Info sheet

Waste valve "plane", suitable for HL shower tray drains series HL570 and HL520F

Fig.2

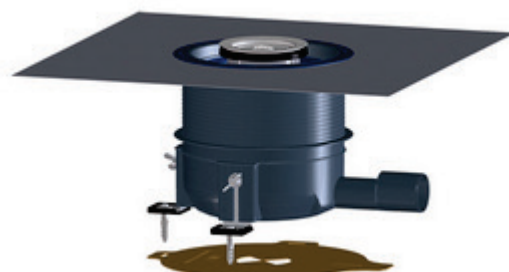
The new HL0570.7E waste valve has been specially developed for shower trays that do not comply with the standard specifications for the geometry of the drain opening according to EN 251. In detail, this concerns the cone of the drain opening, which is flatter in such trays.

In practice, such shower cups are not immediately recognizable to the installer at first glance. Only when the tray is connected to the waste fitting does it become apparent that the edge of the waste valve plate does not rest on the shower tray (see Fig. 2) and that there is no level connection in this area. The water can also not drain completely in this place. With the new waste valve HL0570.7E, which differs from the standard waste valve only in the angle between the valve plate and the threaded part, it is now possible to connect non-standard shower trays with HL drains safely and professionally (see Fig.1). The new waste valve is suitable for shower trays with drain opening of 90 mm and can be ordered individually or as a set under the following article numbers:

Waste valve with locknut in set **HL0570.1E-Plan**Waste valve **HL0570.7E-Plan****HL570.0-Plan** FlexBox with waste valve "plane"
